Lake Crabtree Park Improvements Bid Addendum #2

Date: 08/28/2026
Wake County RFB #: 26-078
WR Project #: 22-0024-007

Notice to All Bidders:

LANDSCAPE PLAN -
COMFORT STATION

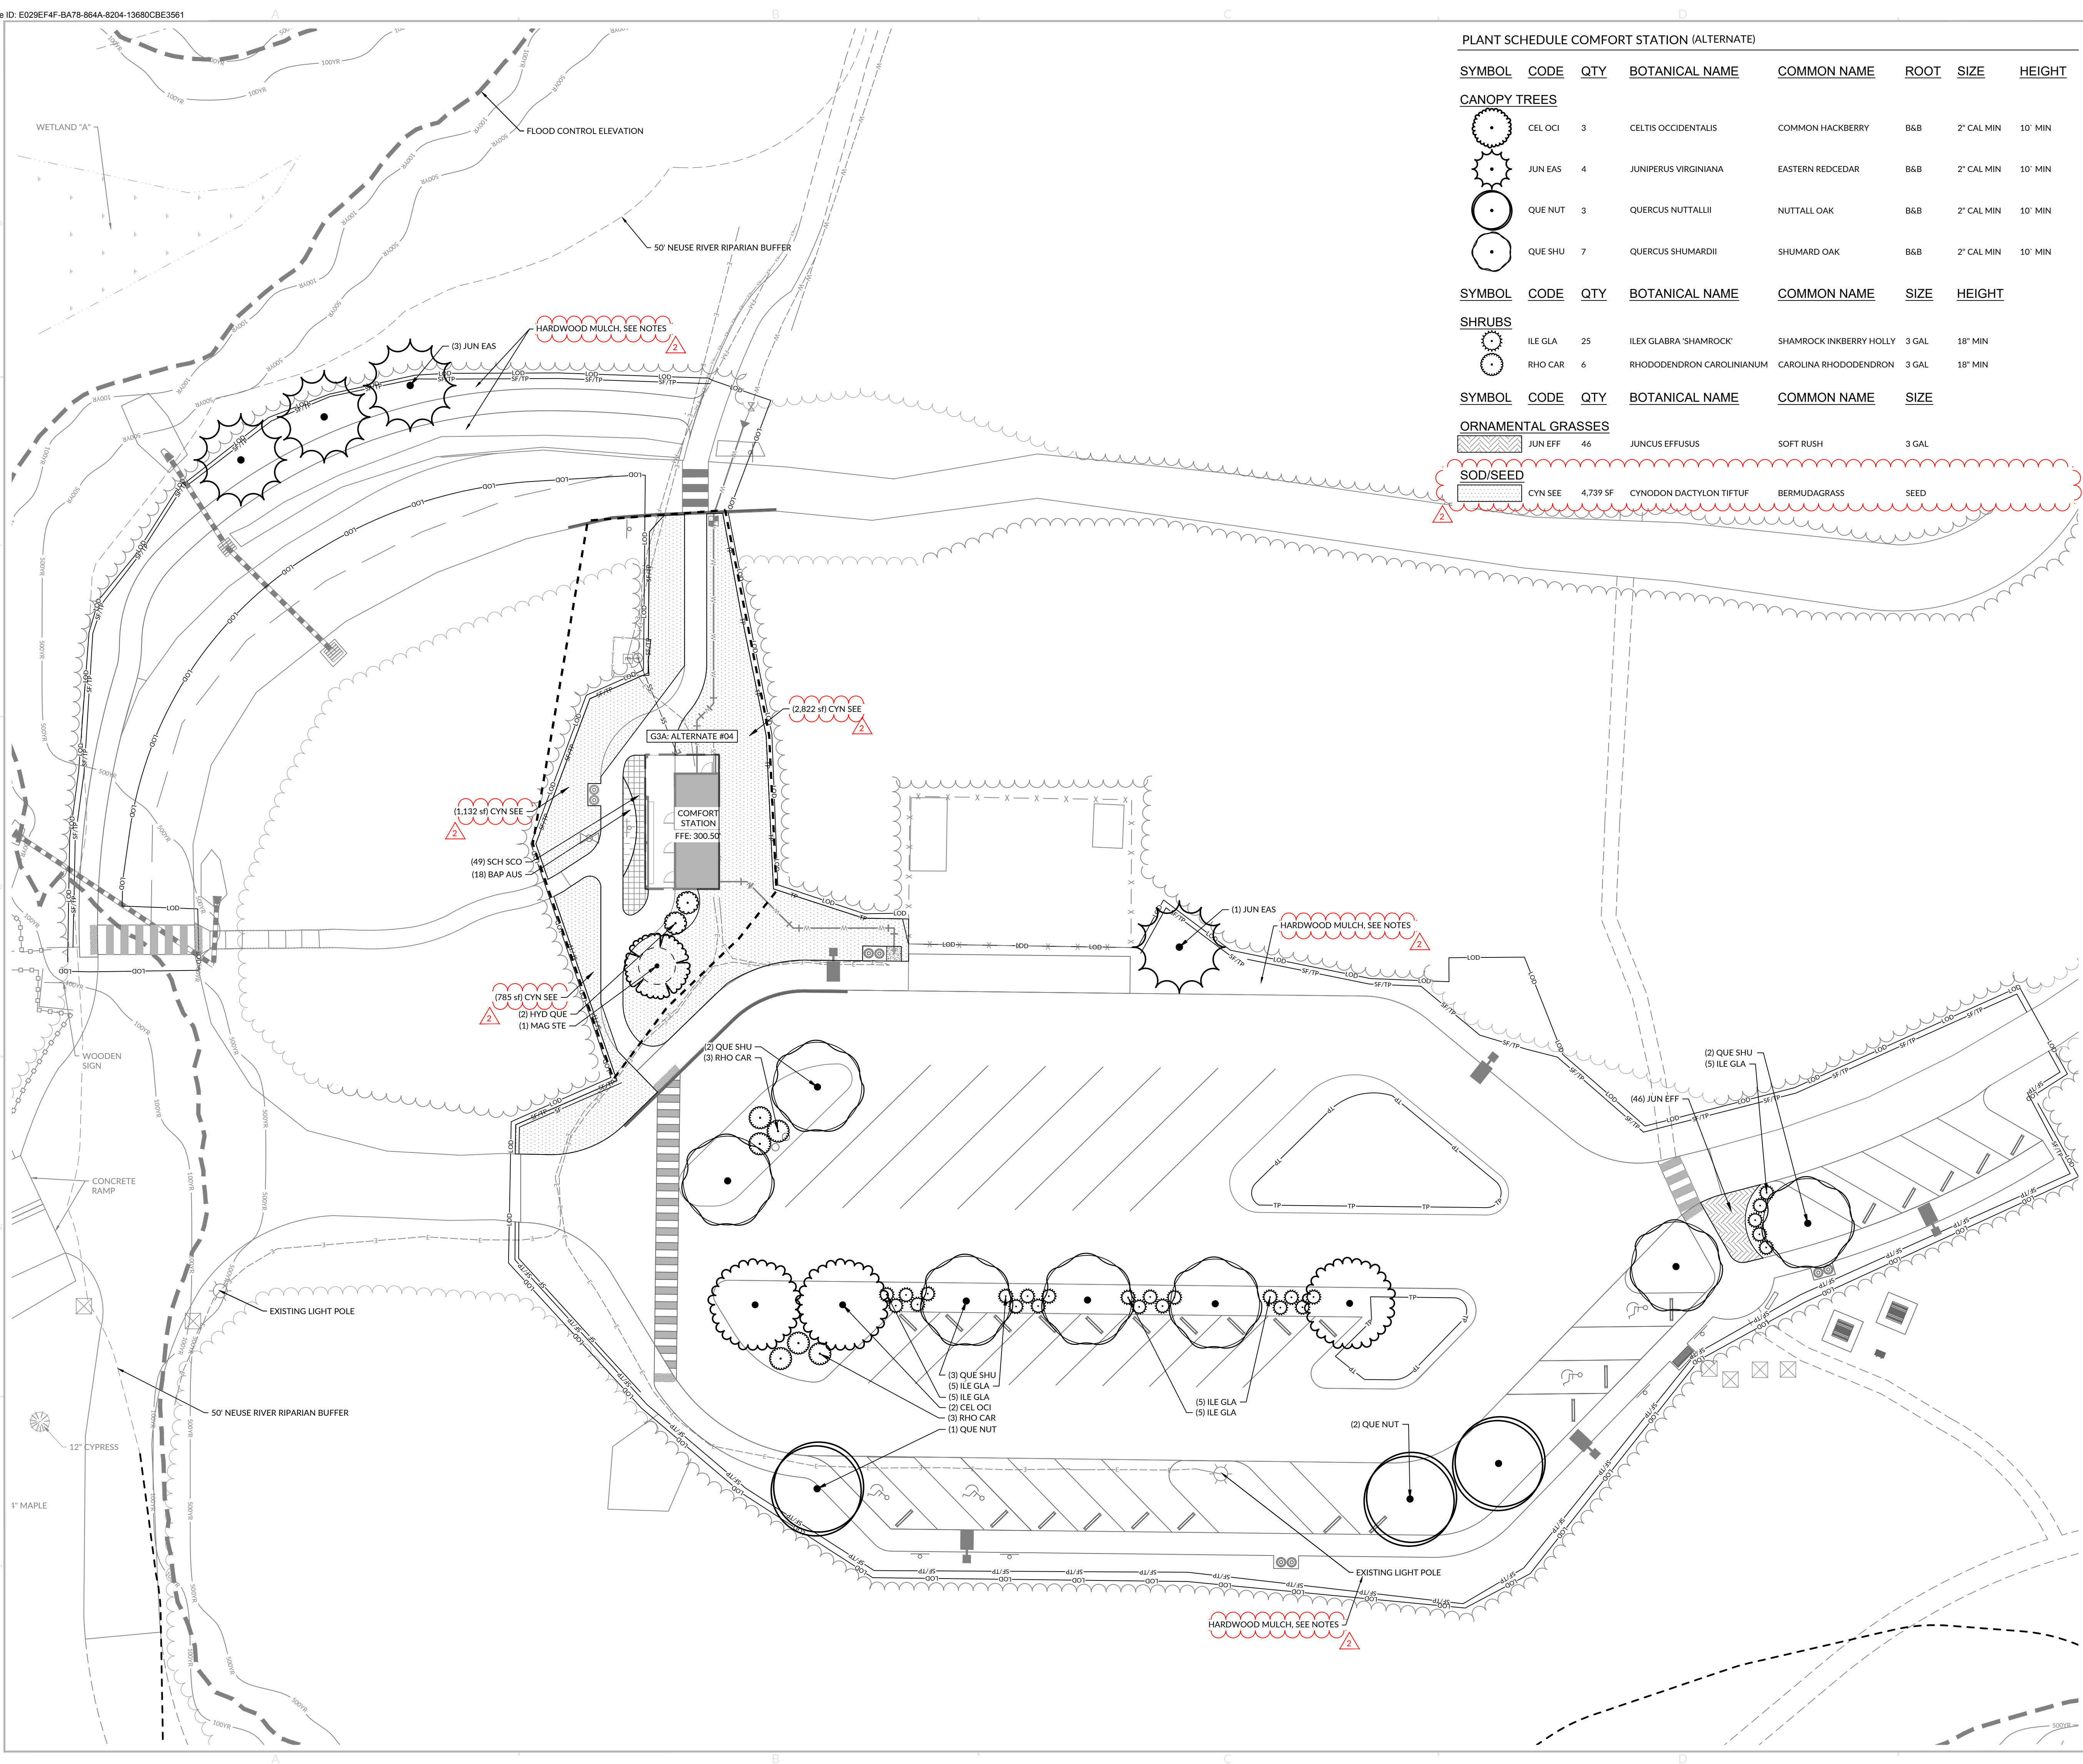
3. C9.07 - UTILITY DETAILS
 - a. Details added
4. L1.11, L1.20, L1.20, L1.21, L1.31 - LANDSCAPE PLANS
 - a. Seeded and mulched areas have been clearly defined on updated landscape plans.

A. **Seeded and mulched areas have been clearly defined on updated landscape plans and plant schedules. See Sheets L1.11, L1.20, L1.20, L1.21, L1.31, L2.00.**

ADMIN BUILDING -
DEMOLITION PLANS

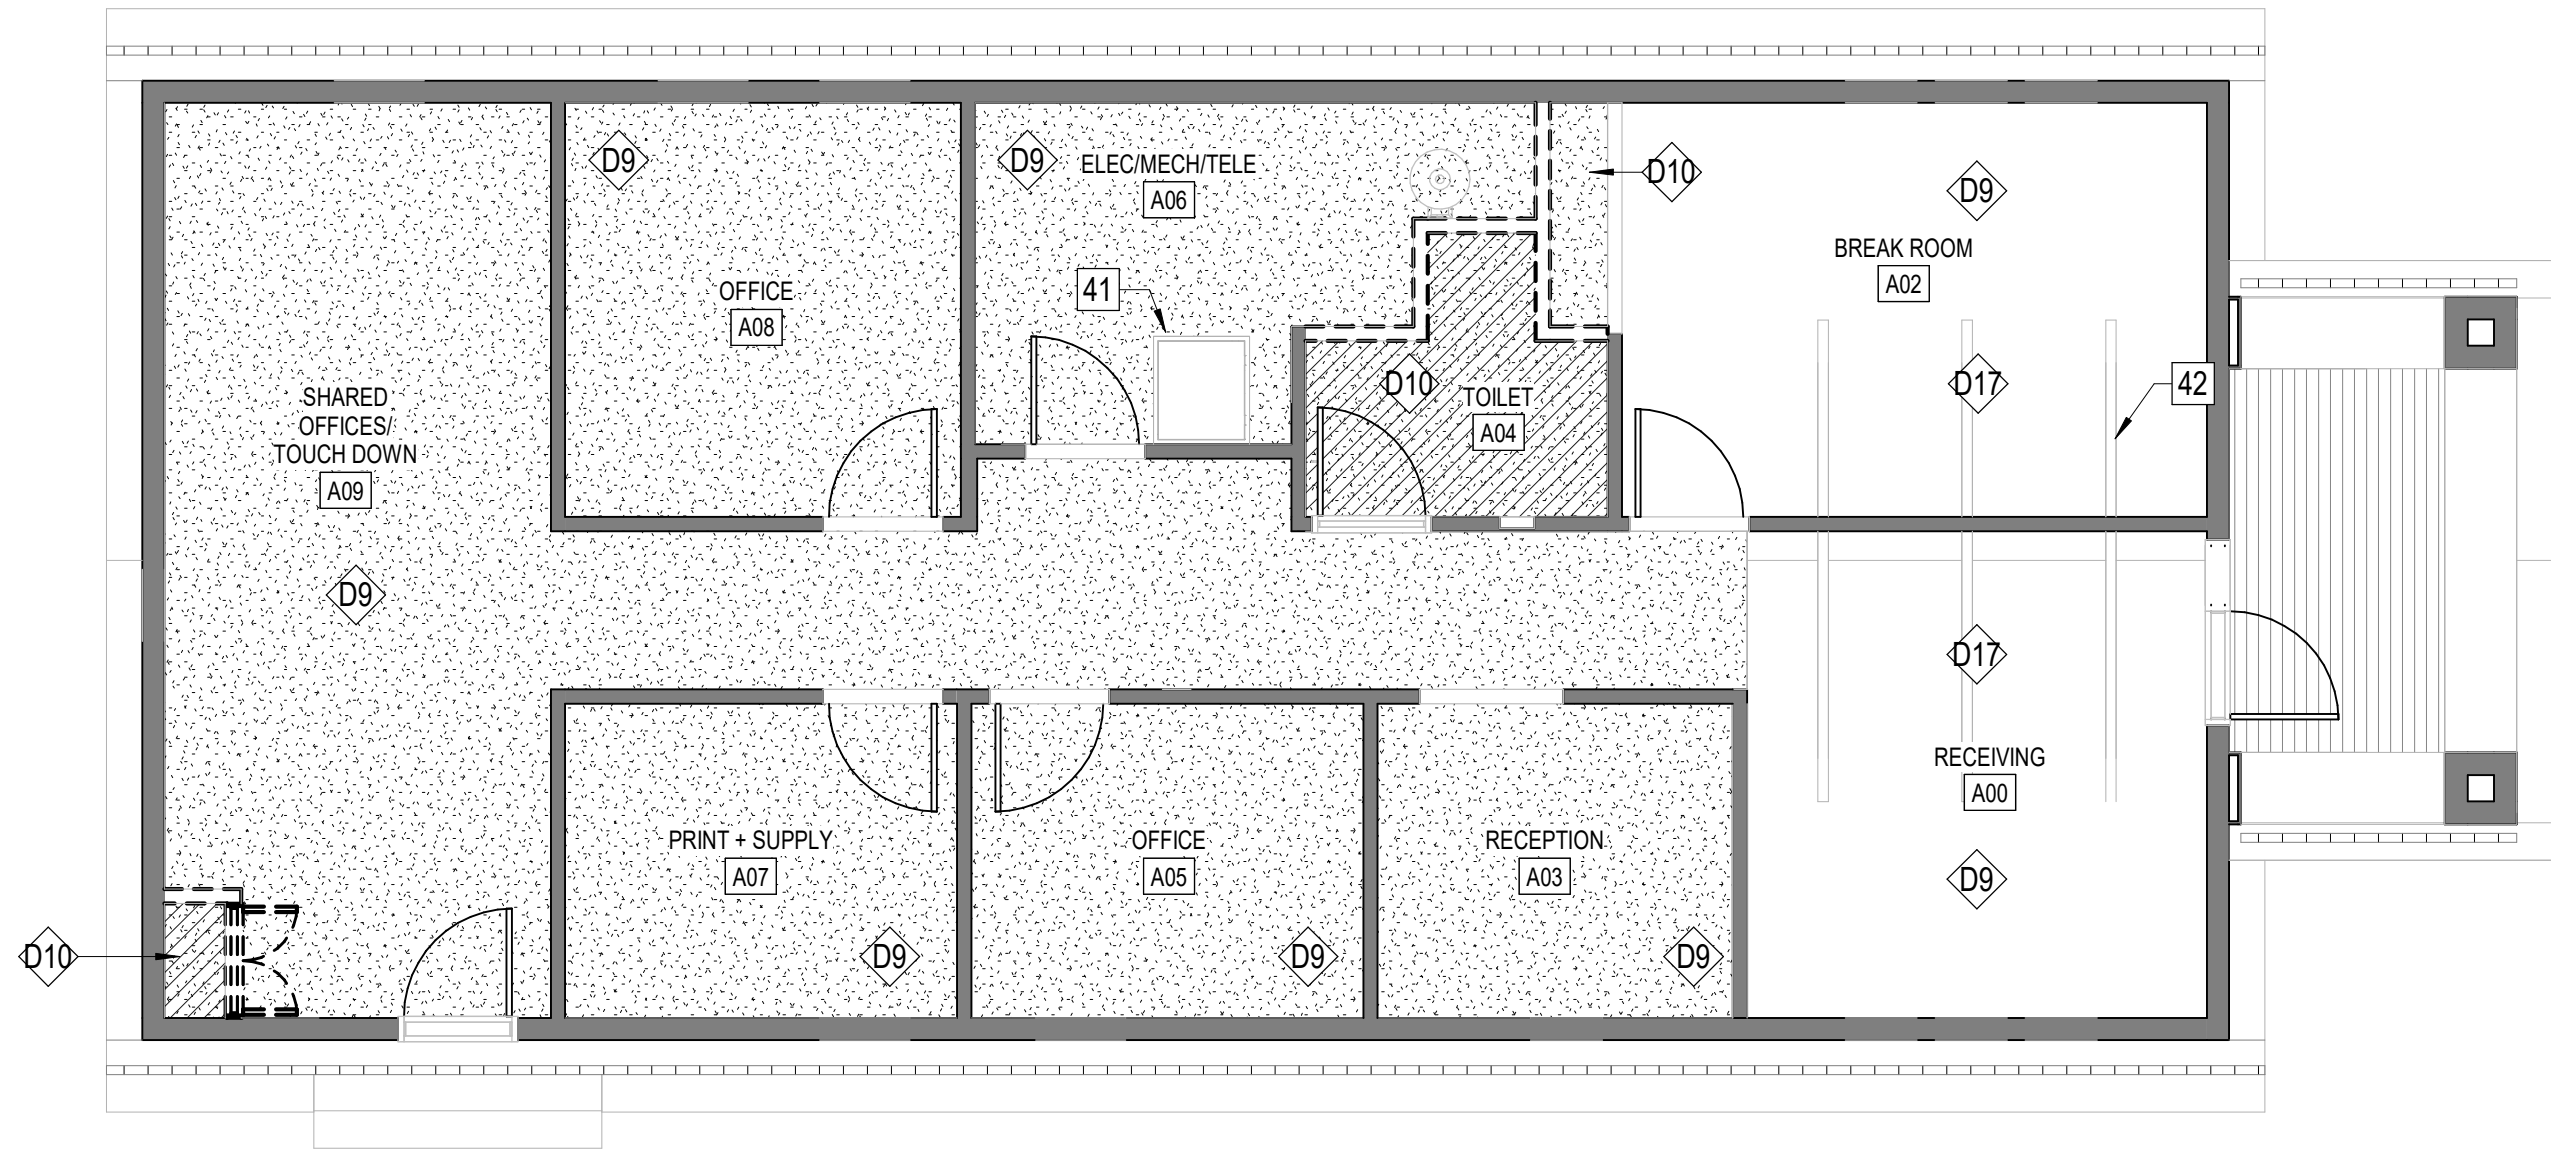
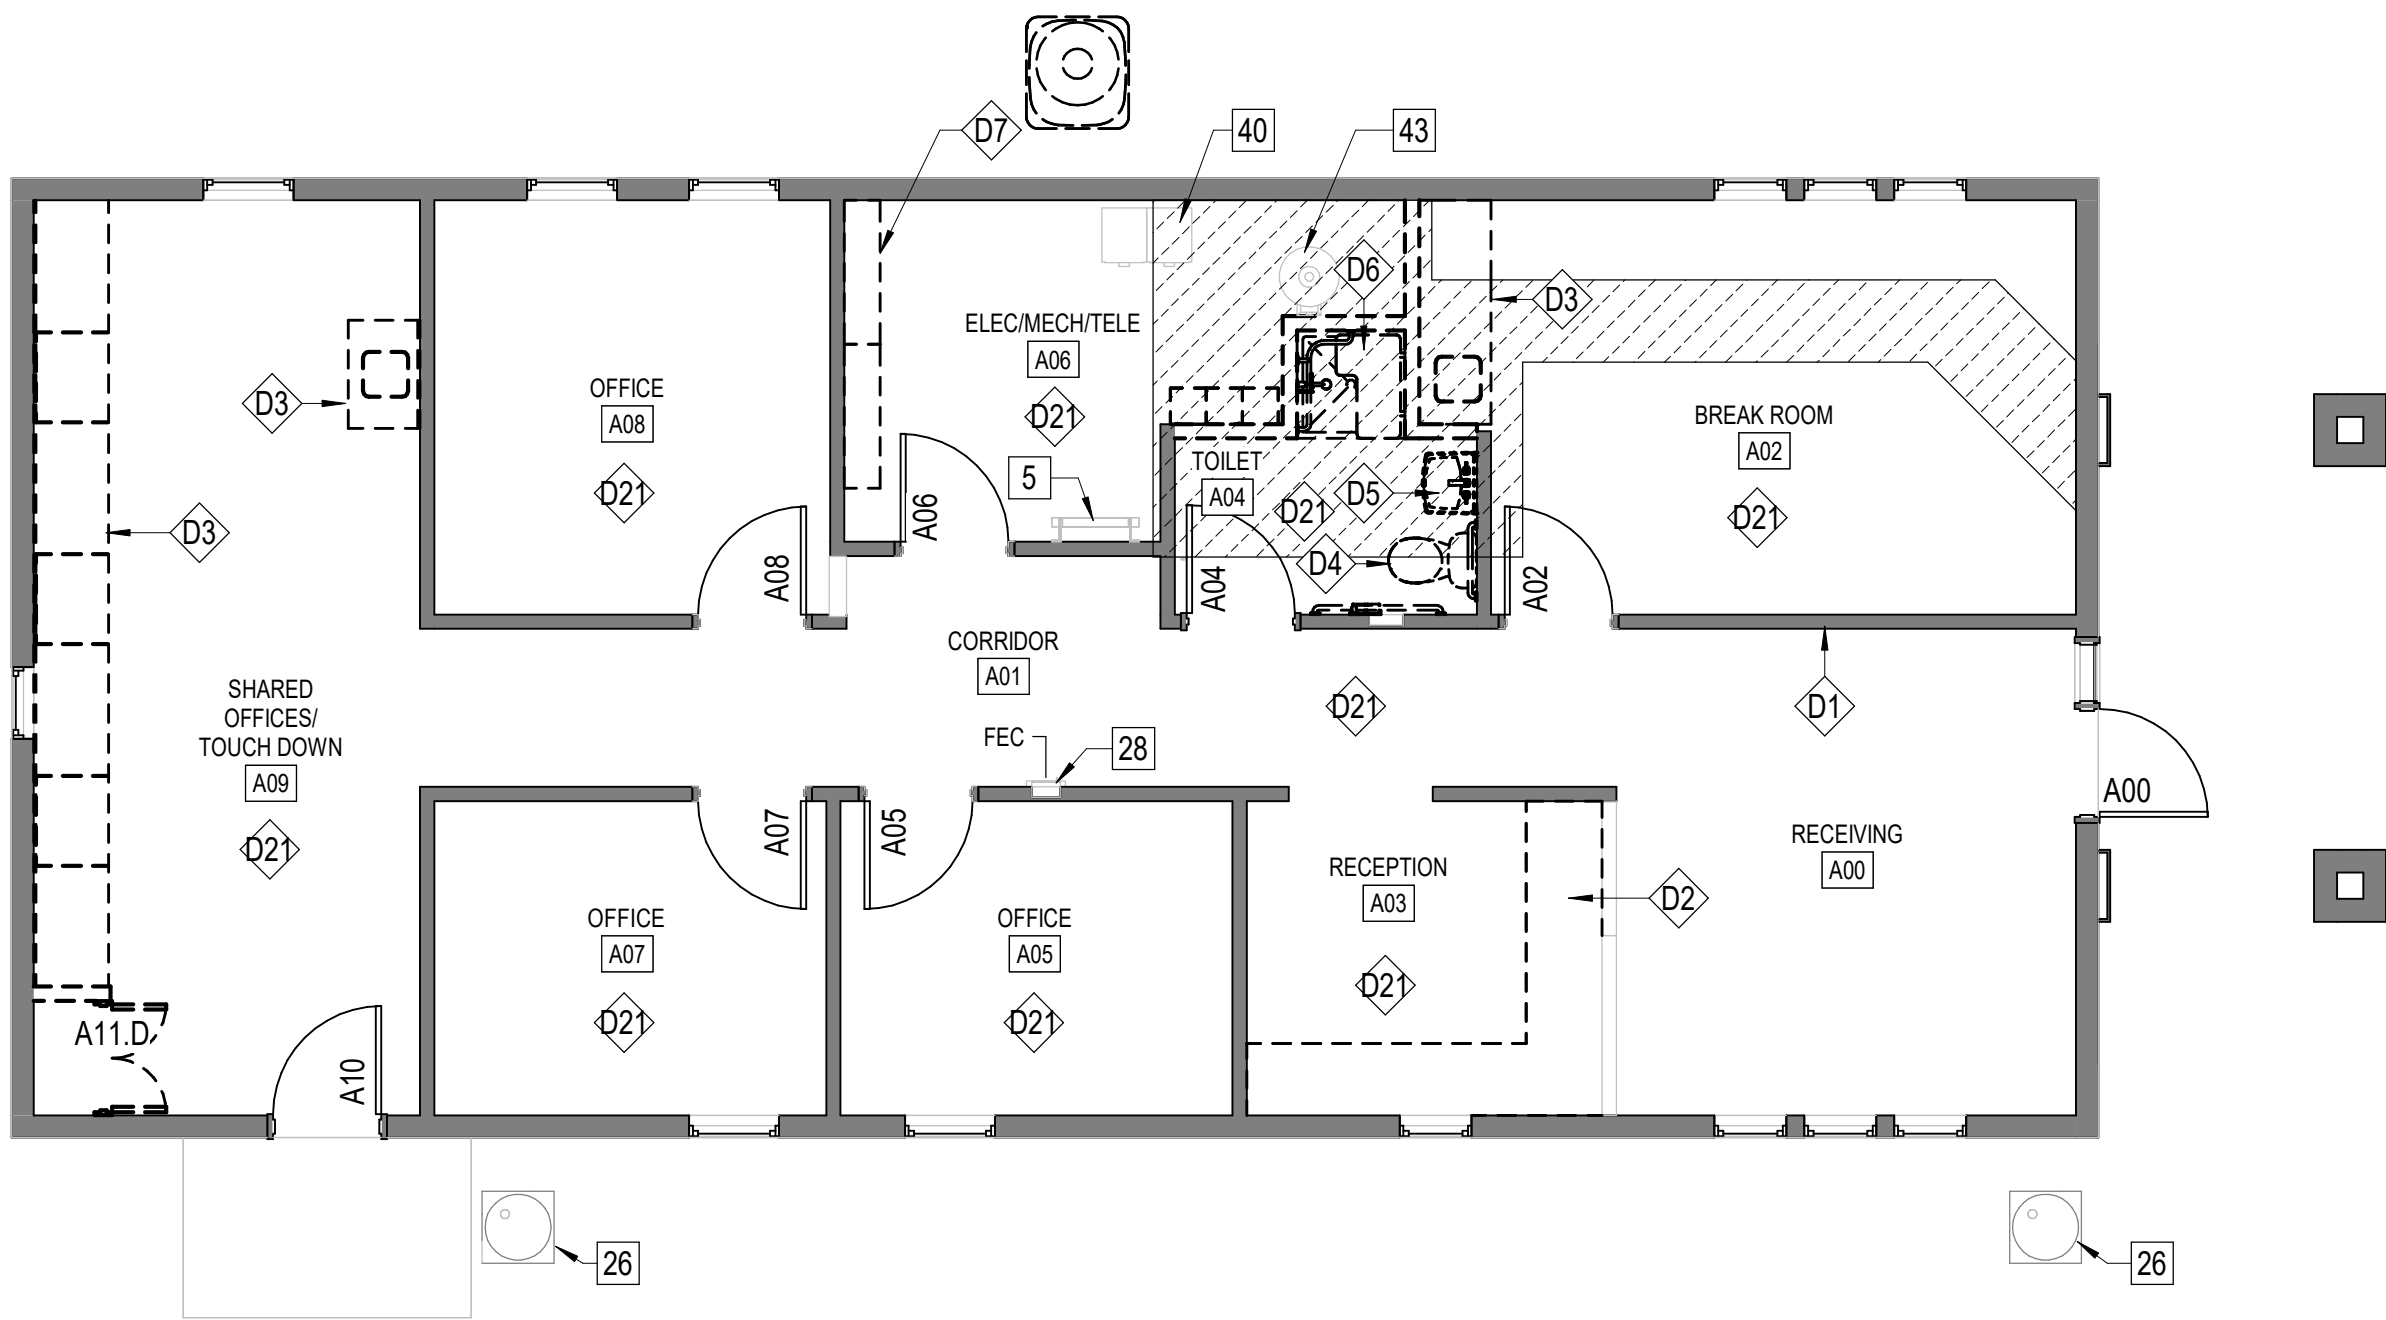
8. A2.00 - ADMIN BUILDING - DEMOLITION PLANS
 - a. KEYNOTE D17 UPDATED. GENERAL NOTE 3 OMITTED.
9. F4.11.A - EDUCATION CENTER - FIRE ALARM PLAN - ALT F-01
